## BULLETIN TECHNIQUE 2016 n°04

### 208R2

13 juin 2016

#### Raccord étrier frein avant (réf. [216708-21](#)) :

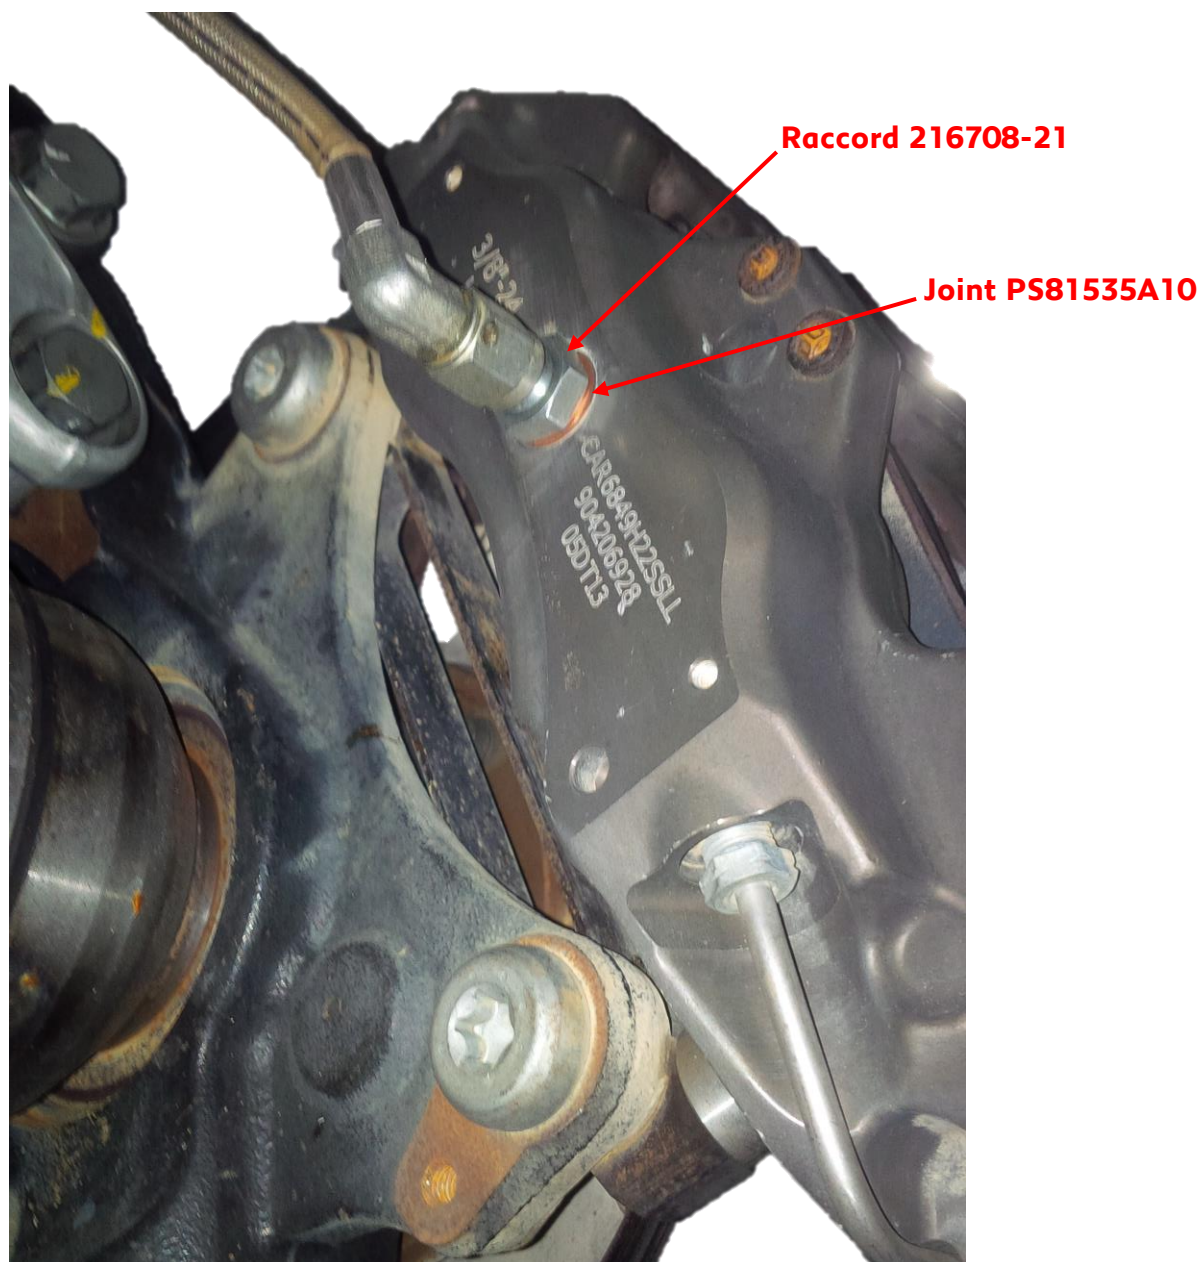
Afin d'optimiser l'étanchéité du montage du [circuit de freinage de votre 208R2](#), le **raccord d'étrier de frein avant de référence [216708-21](#)** doit être utilisé avec le **joint cuivre associé référence [PS81535A10](#)**.

Il est également conseillé de contrôler la propreté de l'ensemble ainsi que le bon centrage du joint cuivre une fois l'assemblage réalisé.

#### Front brake caliper coupling (PN [216708-21](#)) :

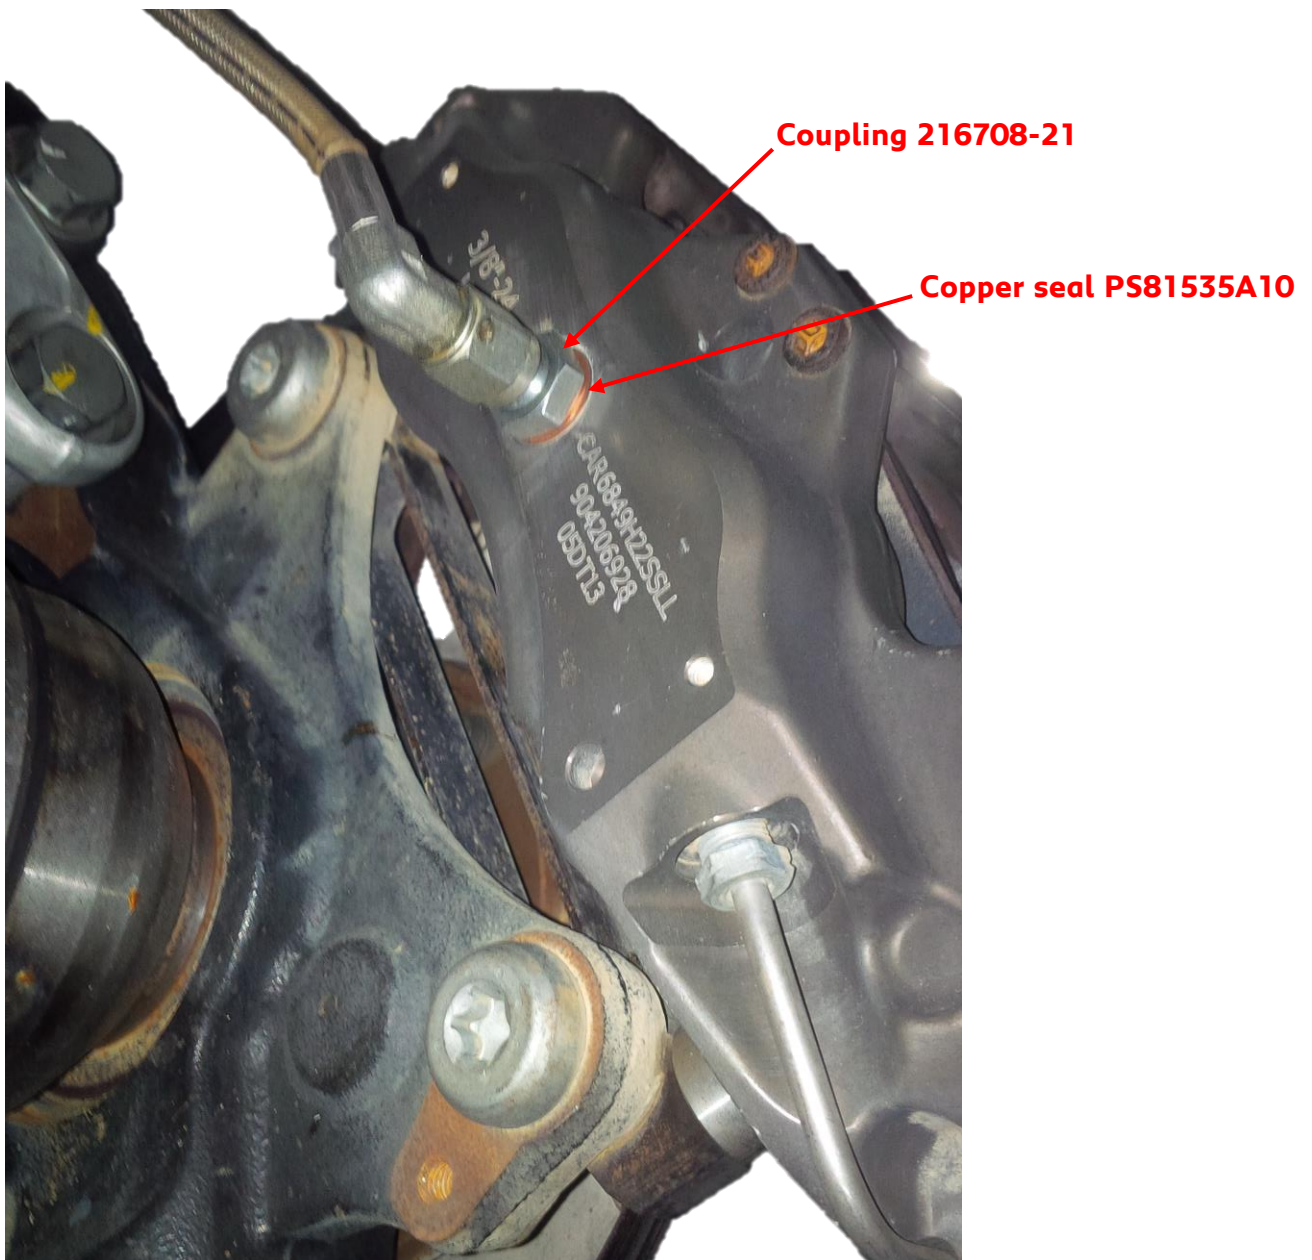
In order to optimize the assembly of [the brake circuit of your 208R2](#), the brake caliper coupling PN [216708-21](#) has to be fitted, together with the corresponding copper seal PN [PS81535A10](#).

We also advise you to check the cleanliness of the assembly and the proper centering of the copper seal once the coupling tightened on the caliper.
